C-NAVY-06-07-2399W

Subject: RPM Meeting Notes and Summary March 21, 2007  
NAVSTA Newport, Newport, Rhode Island

**Meeting Notes**  
**RPMs Meeting, March 21, 2007**  
**NAVSTA Newport, Newport Rhode Island**

**FIGURE 1-2**

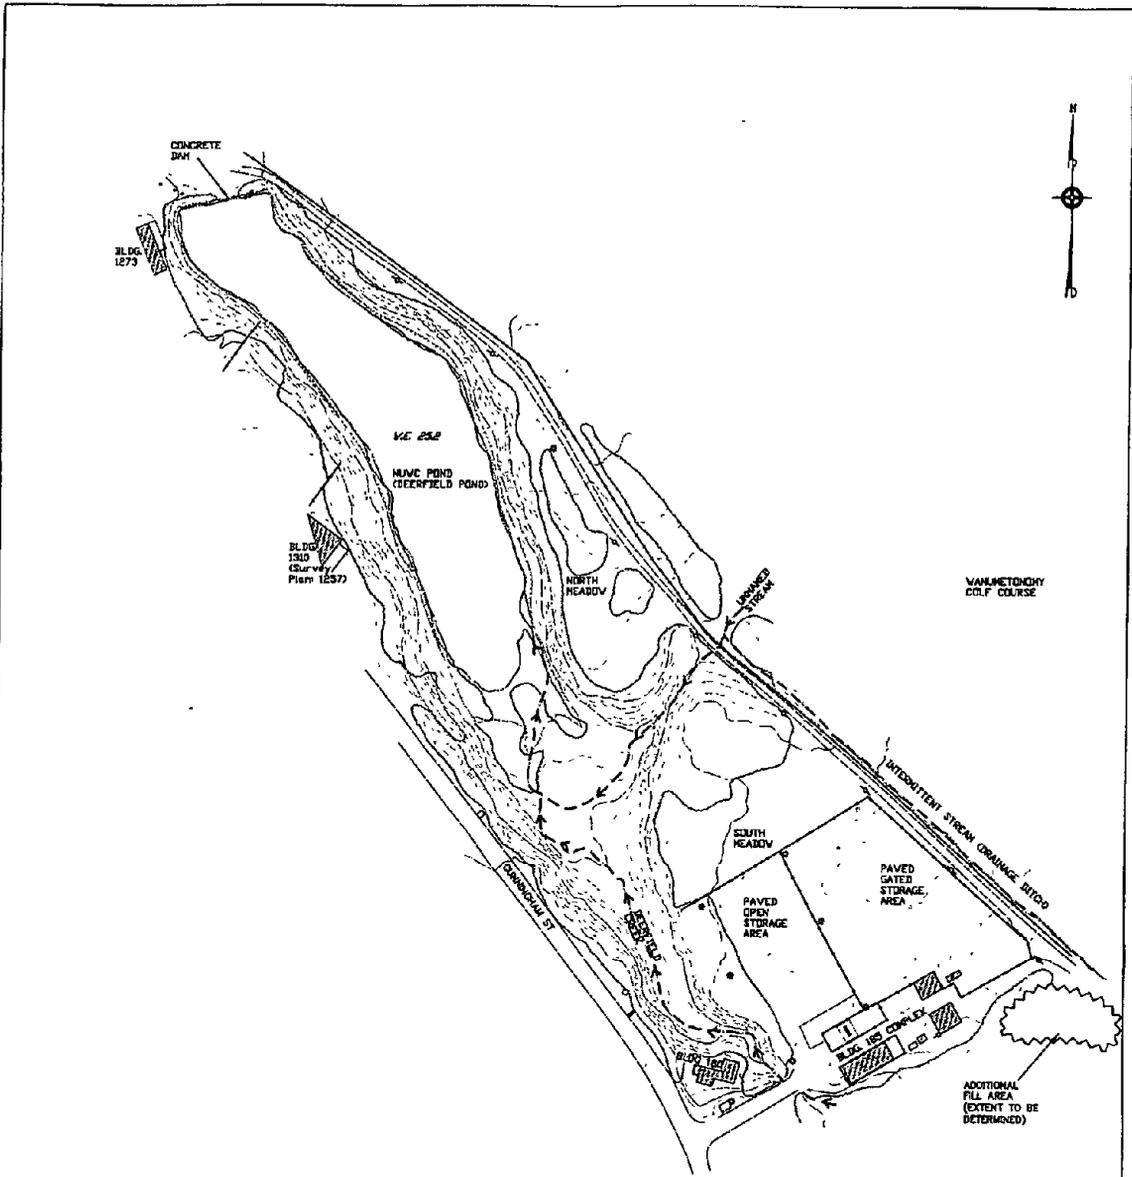
S. Parker noted RIDEM comments that are continuing on the Final NUSC RI work plan. Latest letter was received 3/13/07. Two items were requested: Map revision that showed the extent of fill in the southern area, and a further explanation of the collection of the benthic diversity samples.

S. Parker provided a revised map at the meeting that shows the area where fill was found, and notes "Extent to Be Determined". S. Parker clarified that the empty drum found in the wooded area by P. Kulpa in December 2006 is off the boundary of this map (provided attached to these meeting notes). P. Kulpa stated that map was acceptable for the present, and expressed his interest to see this area tested. J. Colter stated that the test pits will be done in this area, but if the findings are that the material only has rubble or other solid fill present, it will not be considered part of the site. J. Colter also stated that if contamination is found and the area is large enough, this area would be addressed as a separate site. K. Keckler and P. Kulpa stated agreement with this approach.
